CONSUMERS POWER COMPANY

Docket 50-155

Request for Change to the Technical Specifications

License DPR-6

Figure 3-1  
 CYCLE 15  
 BIG ROCK POINT  
 CORE CONFIGURATION

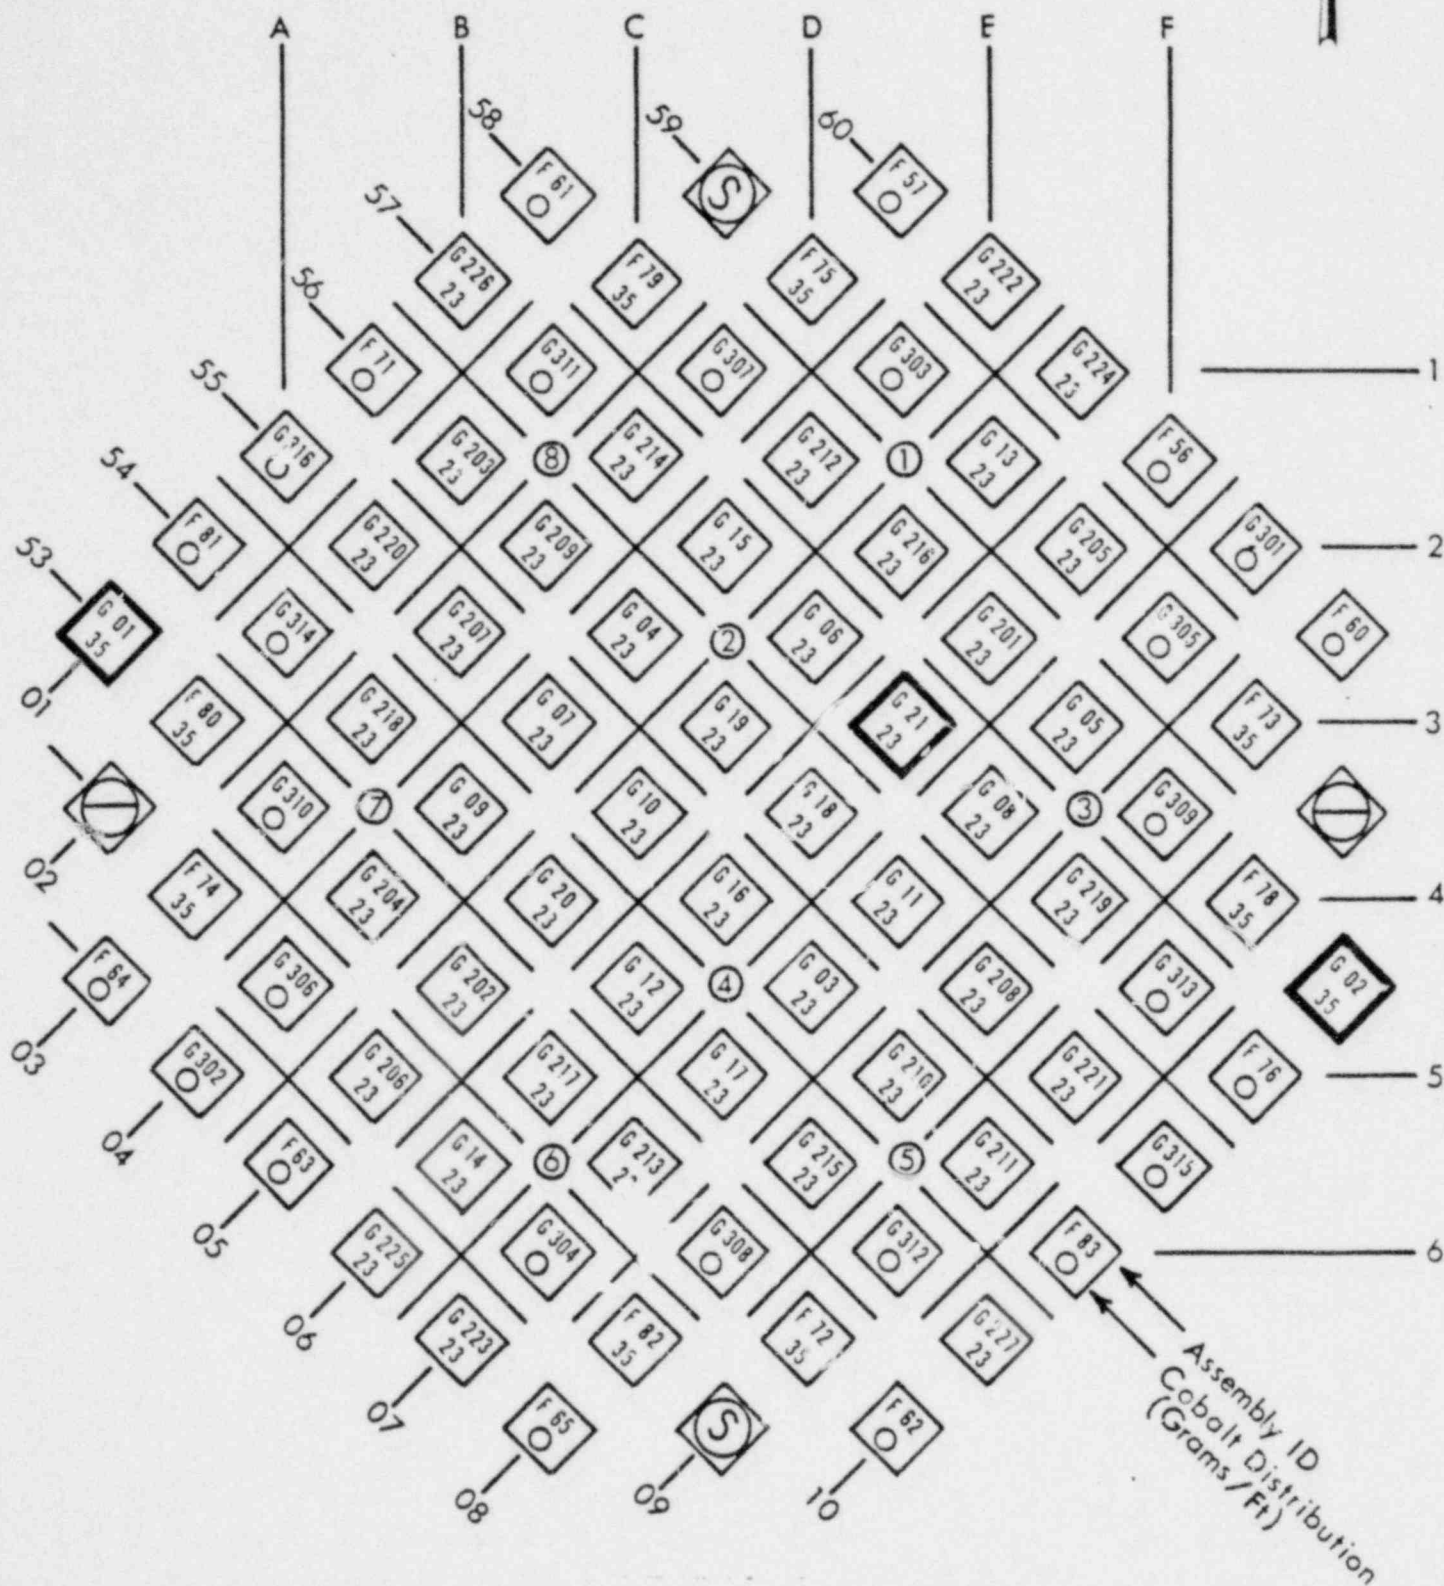
The Cycle 15 fuel loading pattern has been designed to incorporate 180° rotational symmetry throughout the core. The fuel distribution has been developed to comply with Technical Specifications limitations and safety analysis criteria. These limits and criteria include MAPLHGR, minimum critical heat flux ratios, maximum heat flux, maximum control rod worth and minimum shutdown margin among others.

Figure 3-2  
 FUEL ROD ARRANGEMENT - BIG ROCK POINT RELOAD G3

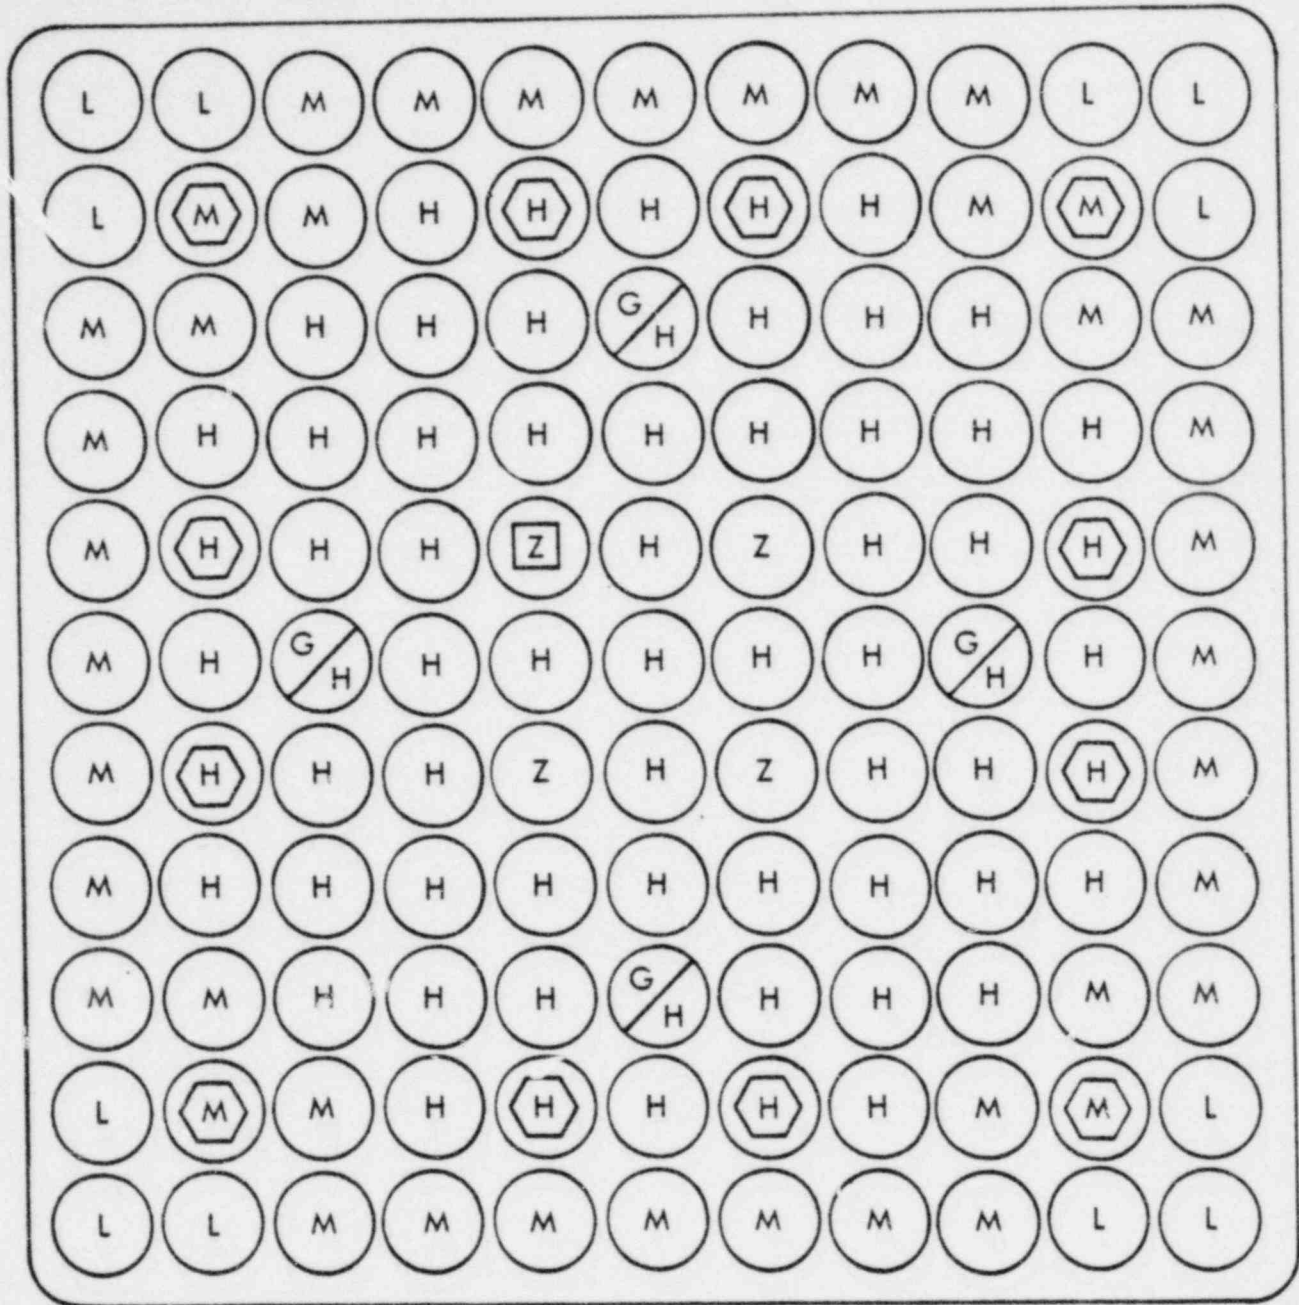
As discussed previously, the major fuel design change for Reload G-3 fuel when compared to Reload G-1U fuel is the elimination of the four cobalt target rods and the reduction of the overall  $U^{235}$  enrichment. Table 4.1-1 lists the design parameters for both the G-3 proposed fuel and the G-1U reference fuel. Table 4.1-2 delineates the fuel inventory at BOC for Cycle 15. It consists of the fuel type, number of assemblies, number of cycles in core, and initial BOC enrichment, density and average burnup. The G-3 fuel is designed to be free-standing throughout its life in core, which is consistent with previous G reload fuels and, like other G fuels, G-3 was initially filled at nominal atmospheric pressure.

Important differences between the reload G-1U and reload G-3 fuel bundle designs are the replacement of the four corner cobalt target rods with low enrichment fuel rods, a change in the gadolinia poison pin locations and changes in the bundle enrichment distribution which reduce the bundle average enrichment from 3.88% for G-1U fuel to 3.14% for G-3 fuel. The effects of these changes on local peaking factor and fuel bundle reactivity have been accounted for in computing the core physics characteristics.

Figure 3-3  
 CYCLE 15  
**BIG ROCK POINT**  
 CORE CONFIGURATION  
 BOL BURNUP DISTRIBUTION

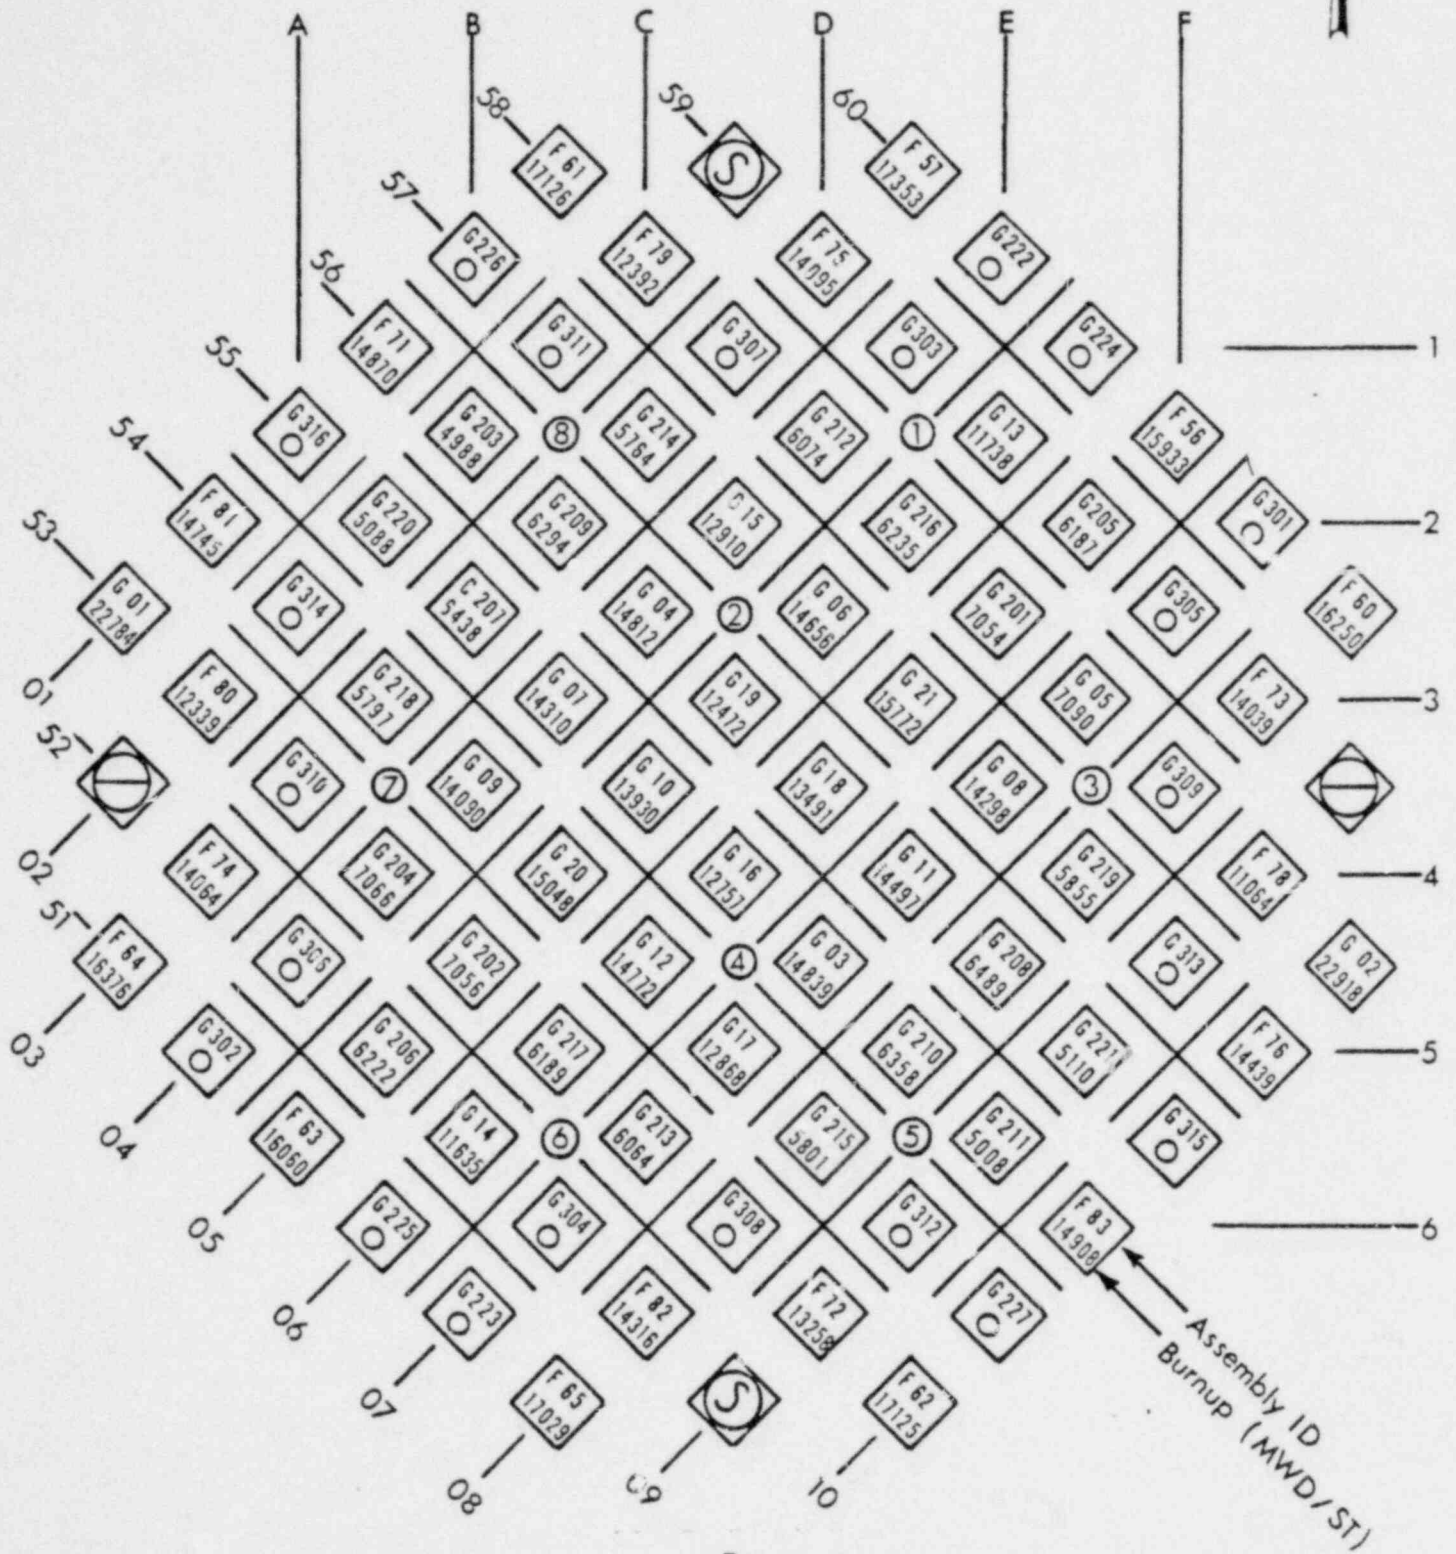
Cycle 15 is designed to produce a target energy of 72 GWD. This corresponds to a cycle length of approximately 325 days of power operation at 220 MW<sub>t</sub>. The projected core loading for this cycle, including cobalt distribution, is shown in Figure 3-1. This loading scheme is subject to minor changes, depending upon the results of fuel sipping conducted during the June 1977 outage, with the goal of making effluent releases as low as reasonably achievable. Figure 3-2 details the fuel rod arrangement, the initial fuel enrichment and the gadolinium distribution and concentration for the G-3 fuel. The gadolinium is designed to burn up in a single cycle; thus, only the new assemblies contain significant amounts of burnable poison. Figure 3-3 is provided to indicate the beginning of life fuel burnup distribution for Cycle 15.

FIGURE 5.1-1  
SHUTDOWN MARGIN VS EXPOSURE  
CYCLE 15

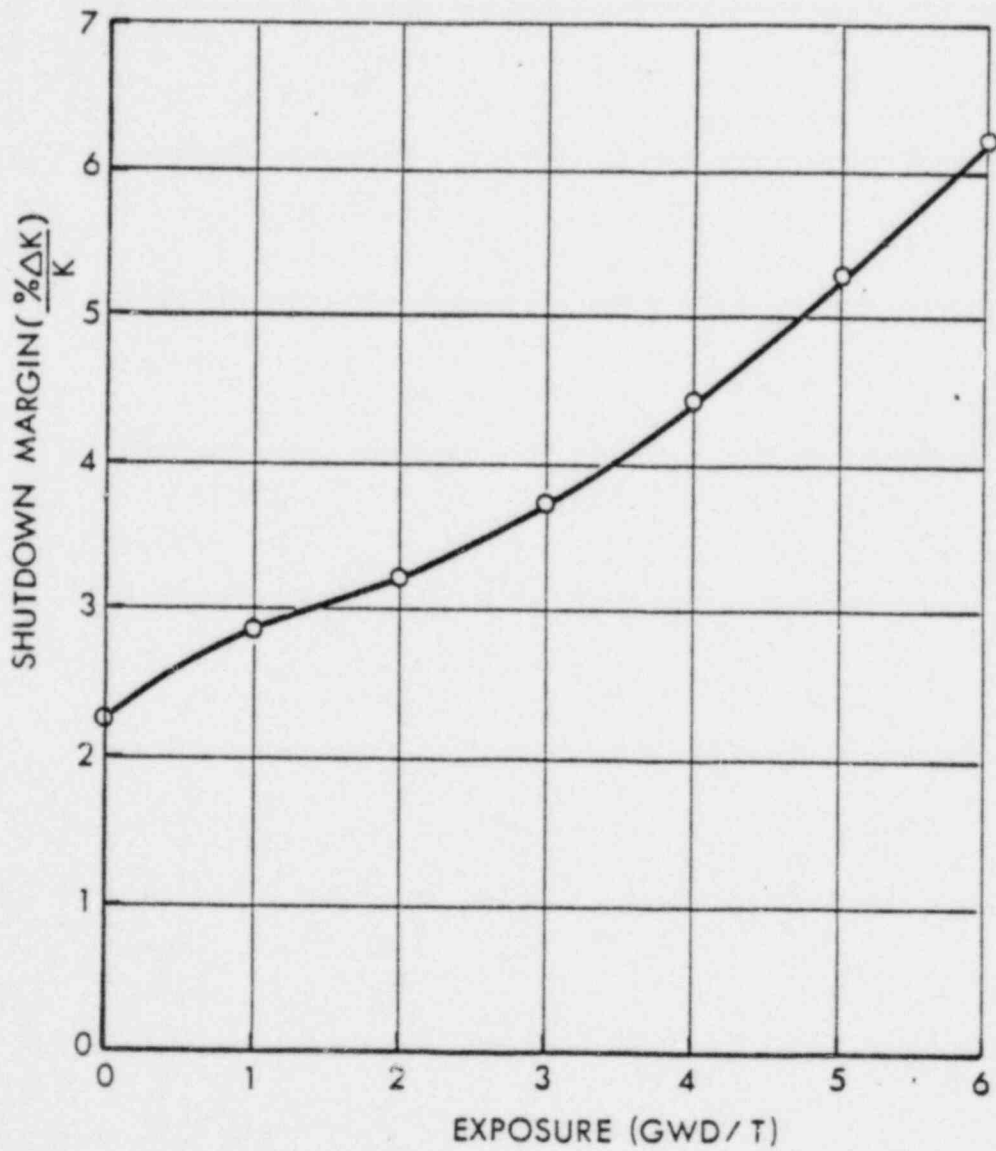
The Cycle 15 core can be maintained subcritical in the most reactive condition throughout the operating cycle with the most reactive rod fully withdrawn and all other rods fully inserted. The Technical Specification concerning shutdown margin is 0.3%  $\Delta k/k$  which is significantly less than the BOC and EOC values for shutdown margin listed in Table 5.1-1. Figure 5.1-1 is the full shutdown margin curve for Cycle 15.

Figure 5.1-2  
BIG ROCK POINT PLANT  
SCRAM CURVE

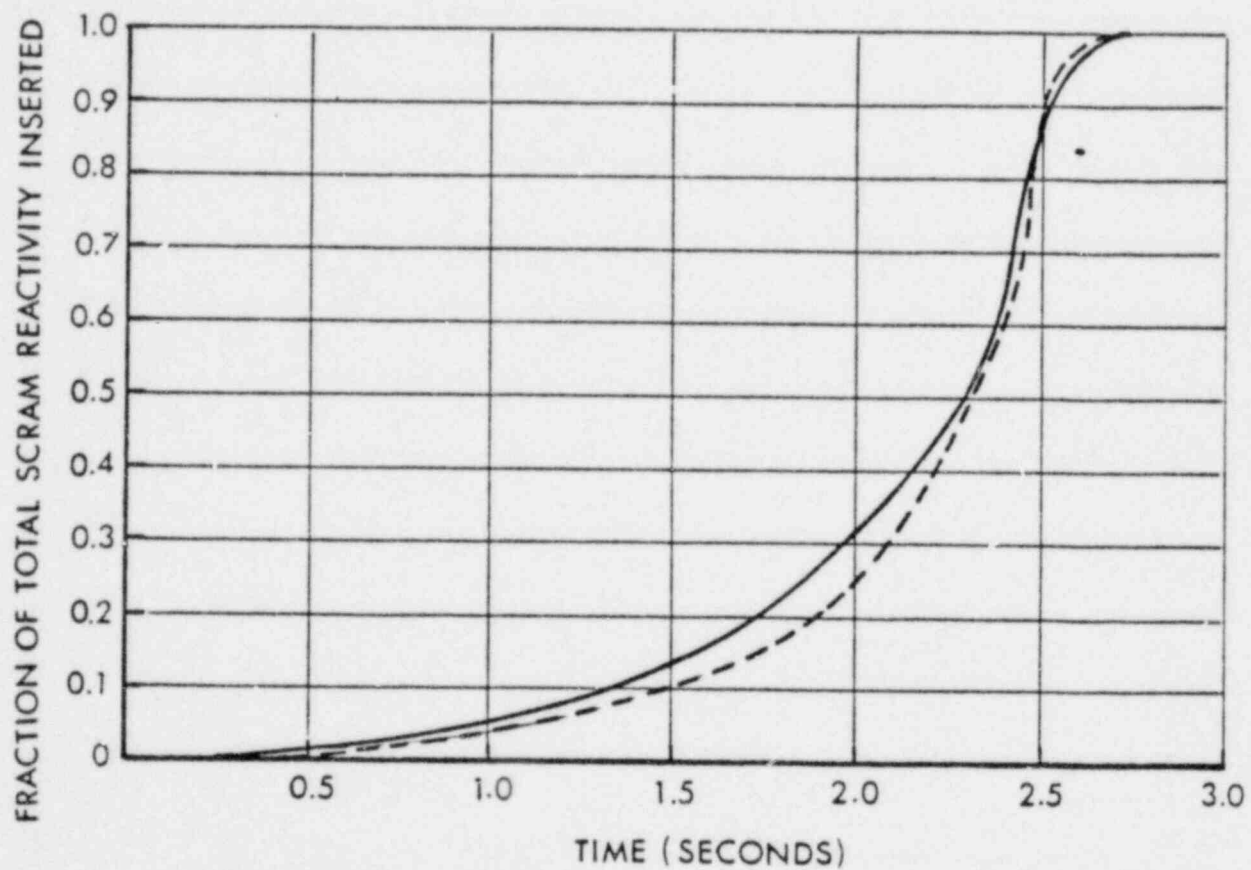
The limiting scram reactivity curve for Cycle 15 is provided in Figure 5.1-2. This curve is most limiting at EOC when the control rod density in the critical rod configuration is the lowest. Figure 5.1-2 is a comparison of Cycle 15 scram reactivity to the bounding curve of Cycle 11. The Cycle 11 curve is considered limiting since it was utilized in the reference analysis of the rod drop accident, the accident most sensitive to scram insertion characteristics.

Figure 9.1-1  
COLD CRITICAL ROD PATTERNS

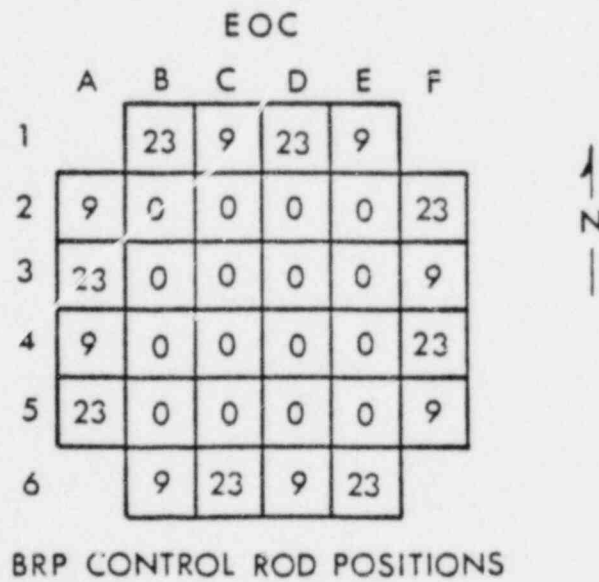
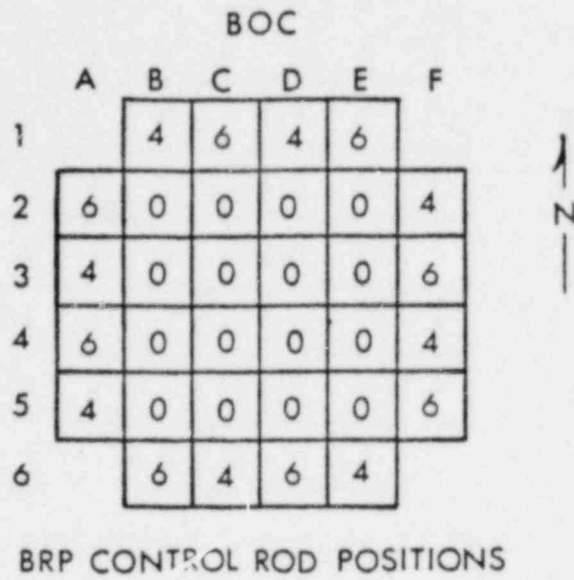
Control rod withdrawal sequences and initial critical rod patterns are analytically determined at the beginning of each cycle. On completion of core reconstitution and shutdown margin verification, an initial criticality at ambient conditions is performed. Integrated control rod worth curves and shutdown margin are adjusted based on the conditions of actual critical rod pattern. On attaining steady state equilibrium conditions at rated power, a reactivity balance is performed and the actual critical rod pattern is verified to be within 1%  $\Delta k/k$  of expected.

Figure 9.1-1 shows the cold critical control rod pattern at BOC and EOC.
